25-27 AUSTIN STREET

RE: 27 Austin Street

Your application to demo a 8' x 14' and to construct a 13' x 16' addition has been reviewed and a permit is herewith issued subject to the requirements listed below. This permit does not excuse the applicant from meeting applicable state and federal laws.

FOUNDATION PLAN

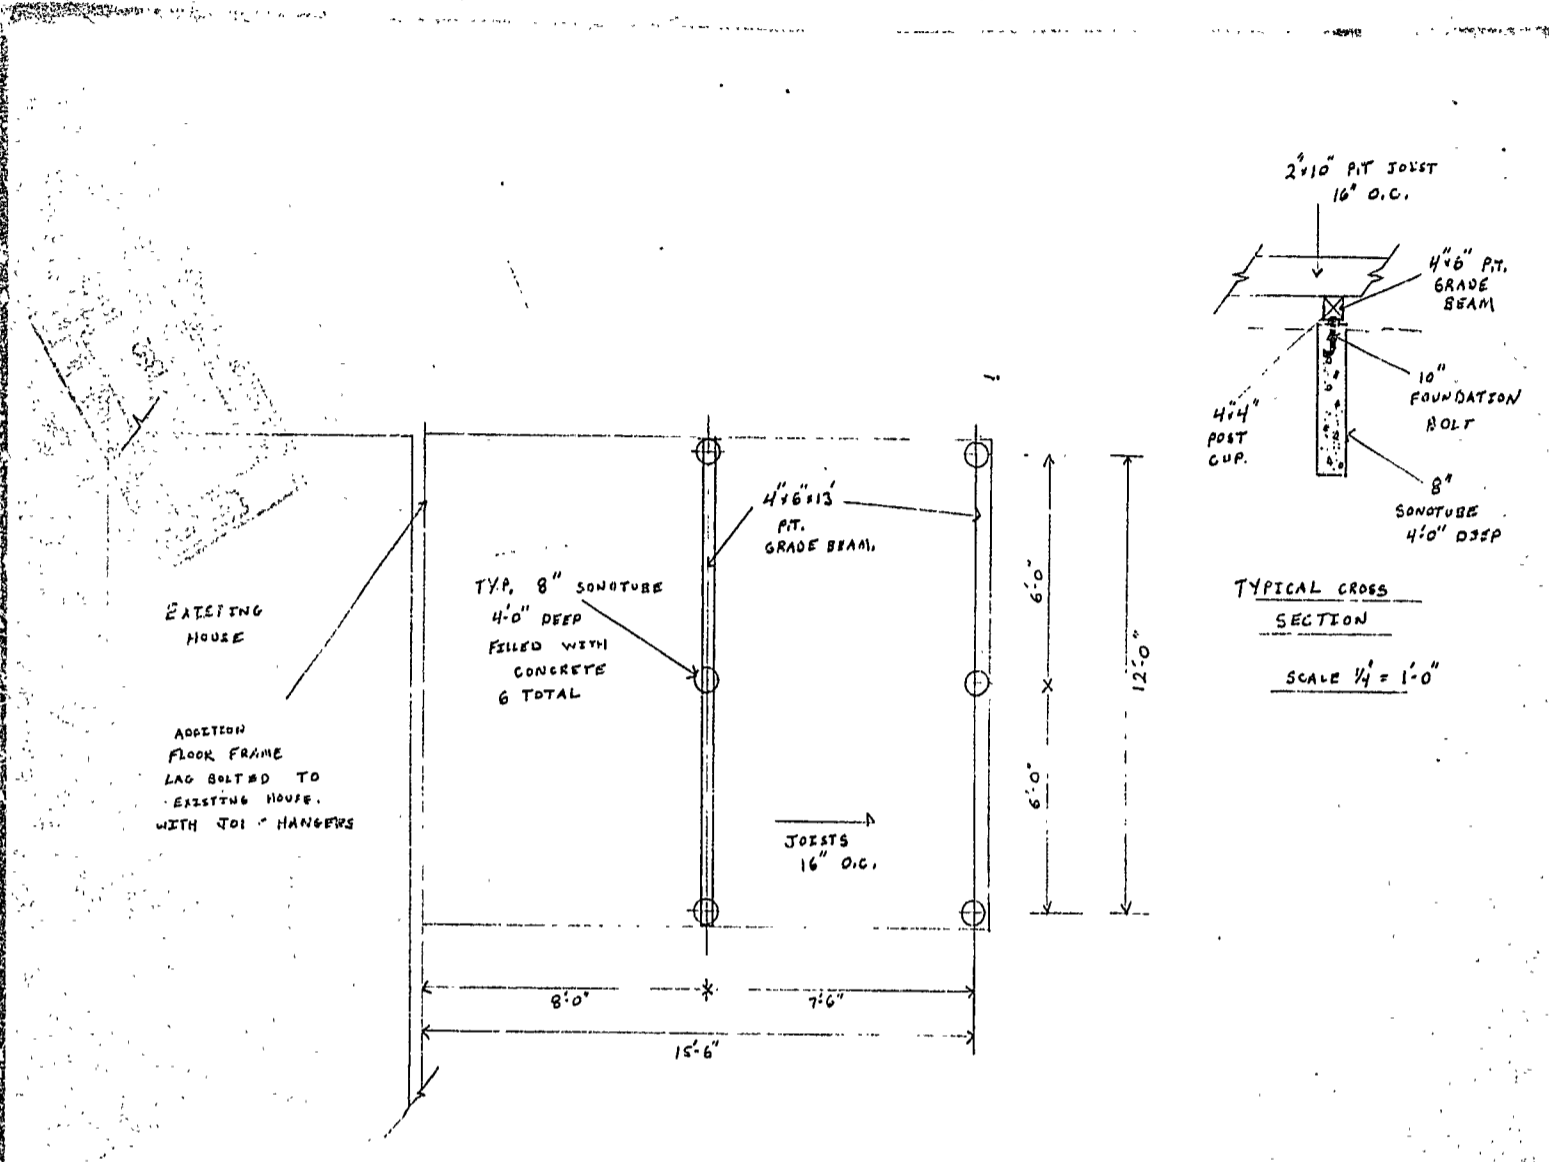
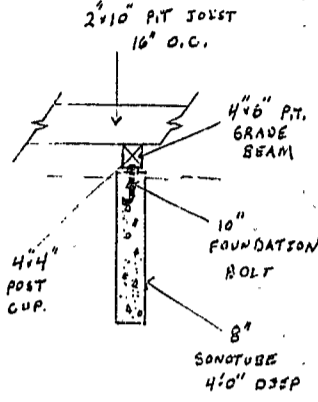
Your proposed plan shows a foundation system of sono tubes. The city's Building Code requires a minimum of an 8" x 4' deep frost wall on any structure larger than 100 square feet. If sono tubes are used, they must be a minimum of 10" tubes on a 24" x 24" footing with anchor between the two.
